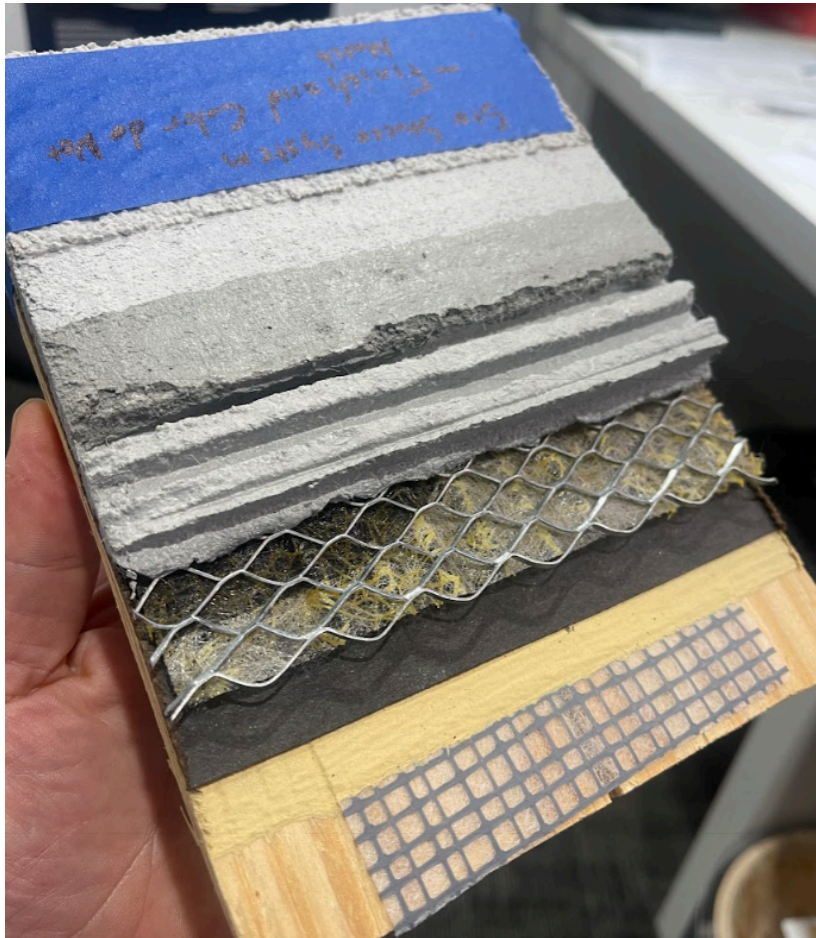
1. Can I state that the lines shown on the elevations and renderings indicate the locations of EIFS control joints? (see below): **BP: Yes, they do. Also, please review the material sample below (we will bring it with us on Tuesday, unless you want to review it earlier). This is a three-coat masonry stucco assembly, not EIFS. Also please find typical joint detail ([link](#))**

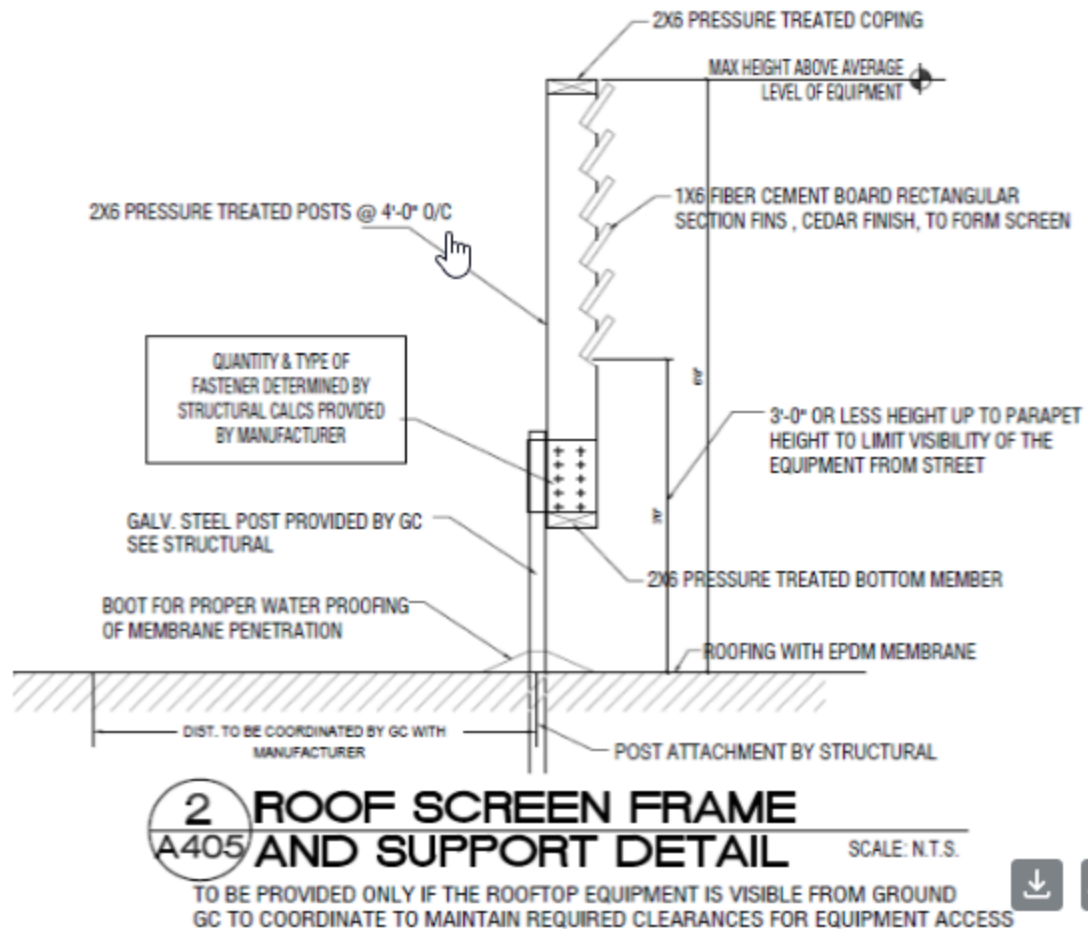
3. No rooftop screening is indicated. While screening is required by the Code of Development, the location, type/material, and design are still under the BAR's purview.
BP: From Nitin, the project architect: There will be one unit (Aeon) sitting on the roof next to the elevators above rooms 5009, which will not be within the perimeter of the building roof. Less likely it will be visible. Although if it does, here is a detail which we would like to provide to hide this :
